Our Ref: RVBC-MH-APP-002 (2)

**PLANNING APPLICATION Ref: 3/2021/0661 - Haweswater Aqueduct Resilience Programme  
Proposed Marl Hill Section (Ribble Valley Borough Council)**

**APPLICATION UPDATES**

Illustration 1 – Indicative appearance and vertical elevations of temporary bridge structures

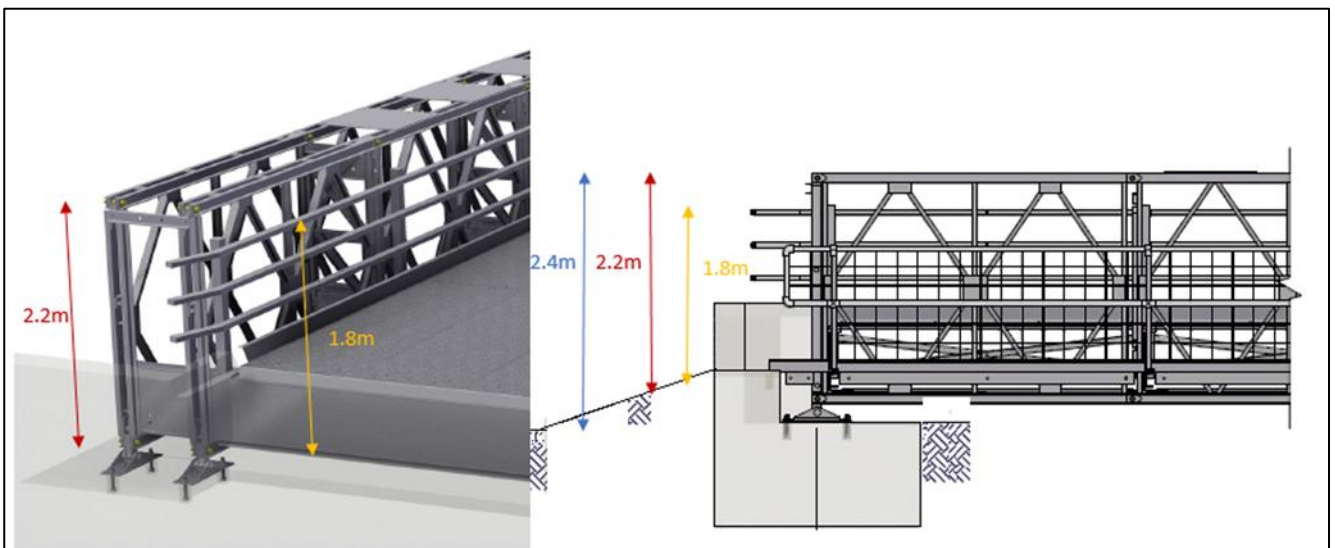
A series of minor alterations to the access track serving the core construction area at the Braddup Compound, off Slaidburn Road, are proposed and result in five minor amendments to the planning application boundary along the access track towards the main construction compound. These amendments are to allow the installation of five temporary bridge structures (commonly referred to as ‘Bailey bridges’) along the proposed access track (see updated construction phase drawings for their locations: RVBC-MH-APP-004-05\_03 and 04, and the updated connection phase drawings: RVBC-MH-APP-004-06\_03 and 04).

The purpose of the proposed temporary bridging structures is twofold:

- To span and protect a series of existing culverts through which field drains currently flow in a north-south direction below the existing road
- To protect the root zones of Grade A trees situated adjacent to the track.

Illustration 1 shows the typical vertical elevations of the temporary bridge structures would be of steel lattice construction and rectangular in shape. Concrete footings for the temporary bridges would be constructed in excavations approximately 1.5 m below existing ground level.
